**Japan Feedbacks against EC/US/UK proposal
on
Part A and Part B program**

52nd EVE IWG Meeting
8th and 10th September, 2021

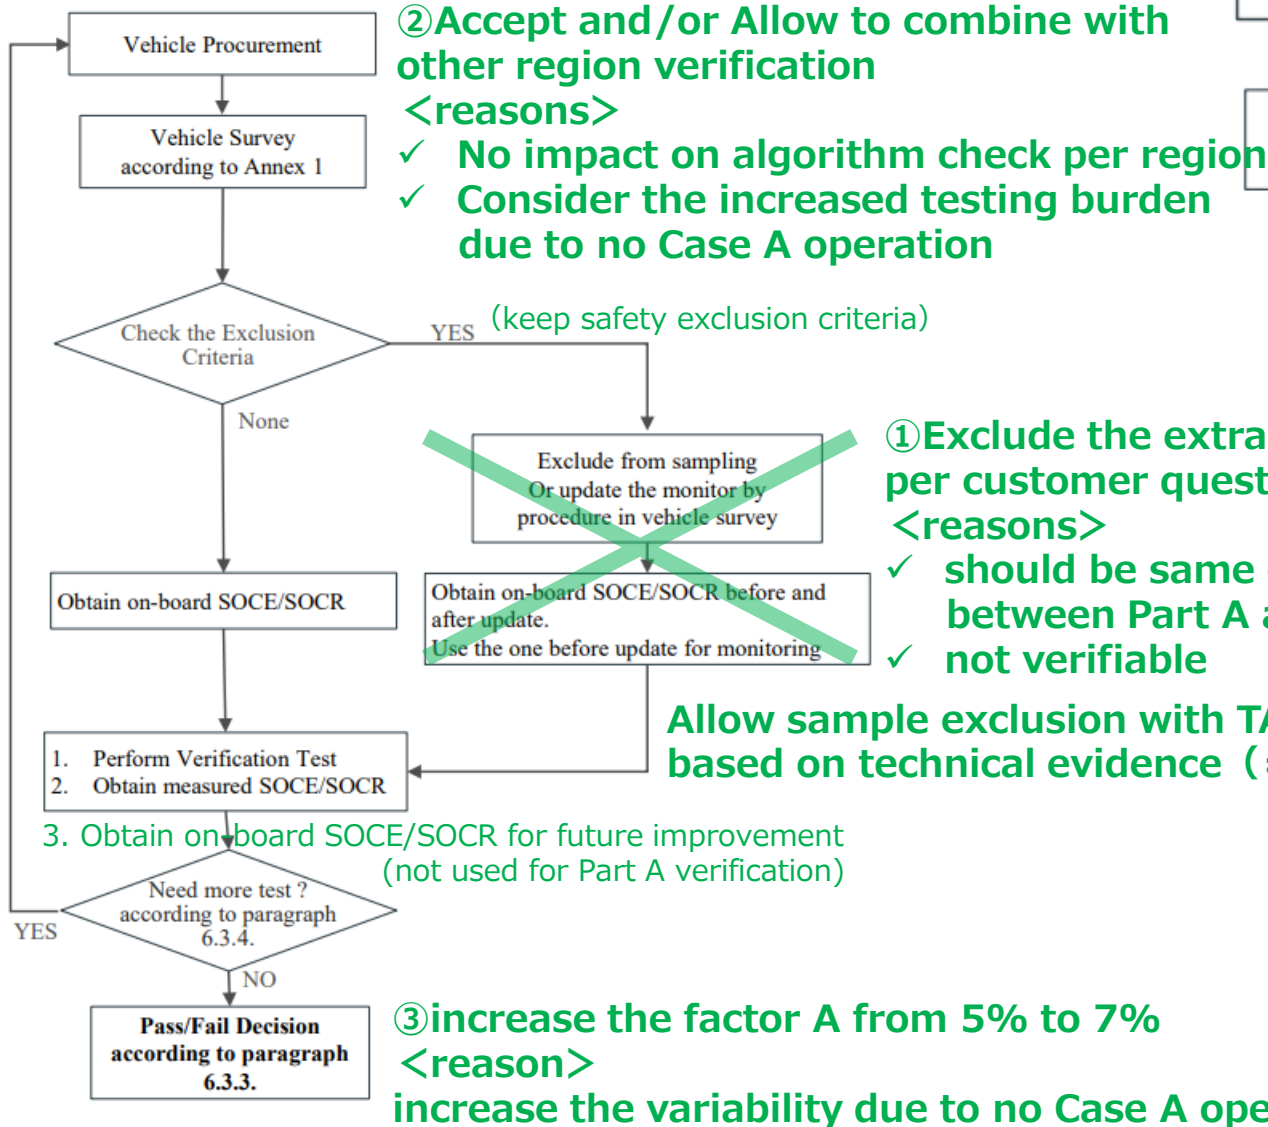
Part A_① Exclude extra operation per customer questionnaire and
allow sample exclusion with TAA agreement

Part A_② Accept and/or allow to combine with other region verification results

Part A_③ Increase the factor A (verification threshold) from 5% to 7%

Part B_① Delete on-board information of OEM exclusion justification

Battery Durability Verification Flow

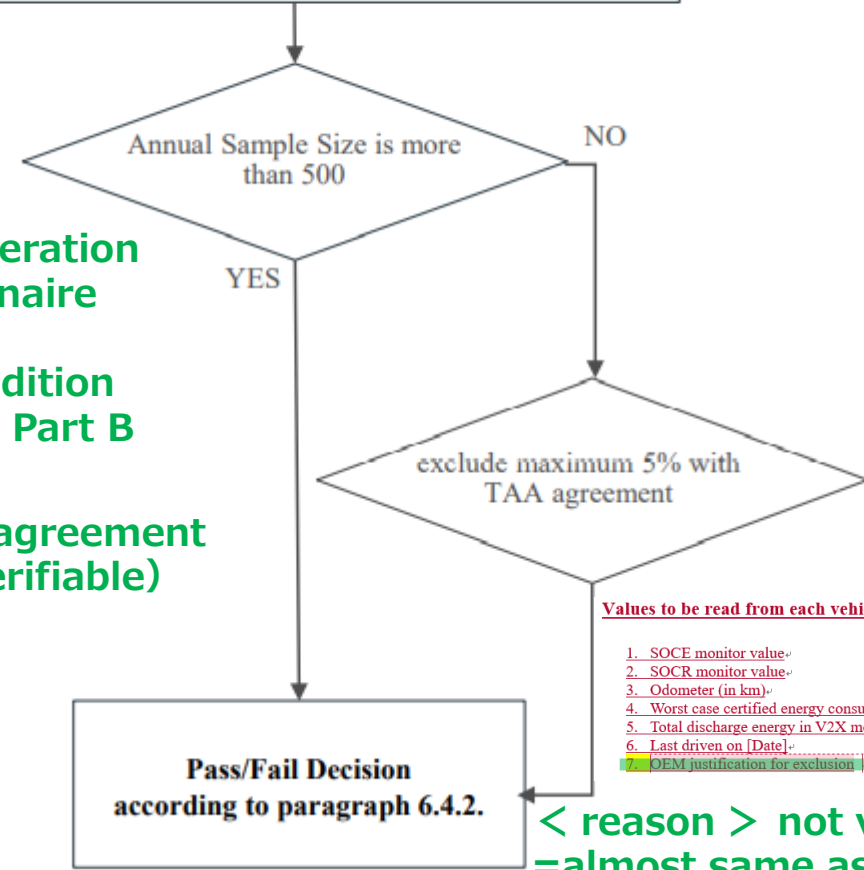
【Counter-Proposal against EC/EPA/UK proposal】

Part A : Verification of Monitors

Part B : Verification of Battery Durability

Japan Proposal on Part A and Part B process

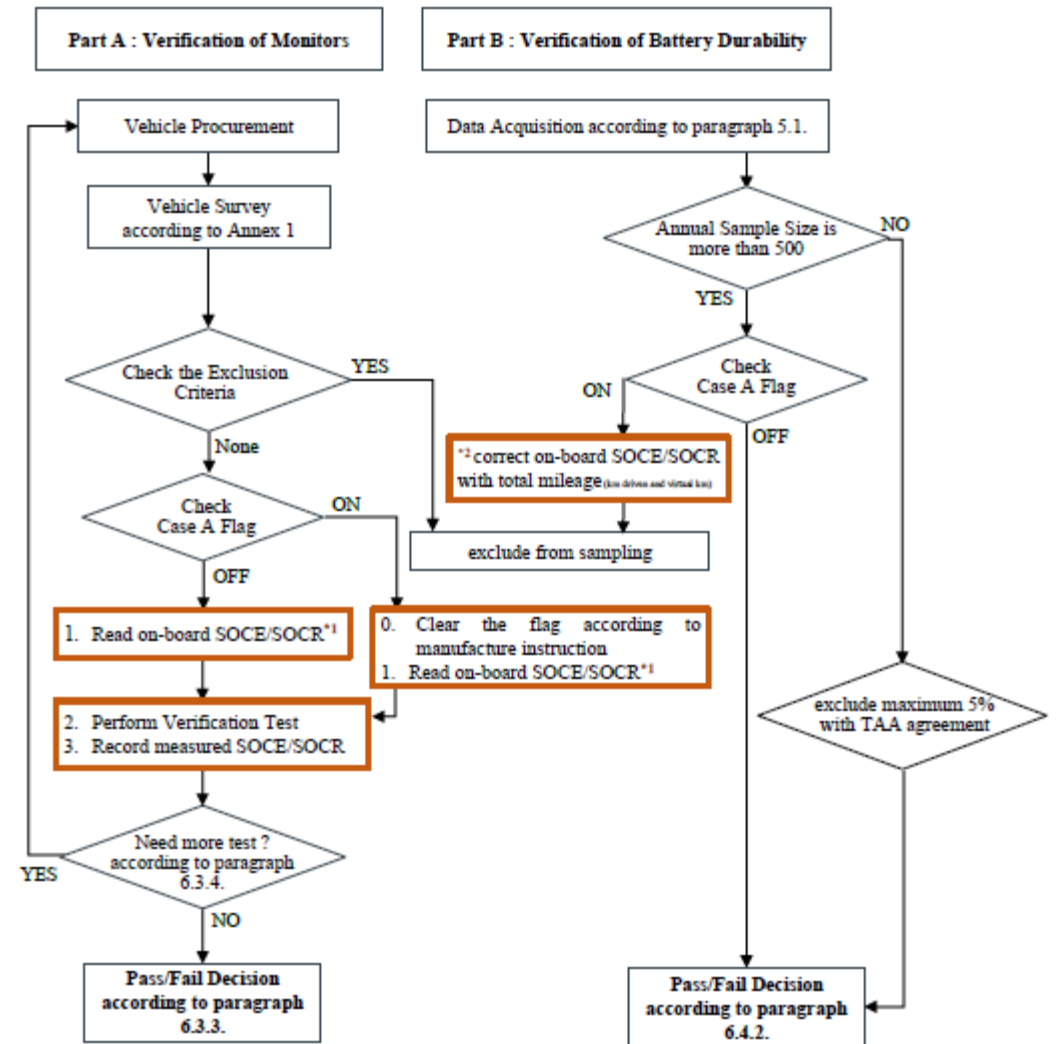
Updated !!!

*1 : on-board SOCE/SOCR before verification test shall be used for $SOC_{real,i}$ (Part A verification) considering the consistency between Part A and Part B

*2 : the additional information (on-board SOCE/SOCR and total mileage) is a kind of "deterrent effect" to prevent the misuse from going into the market
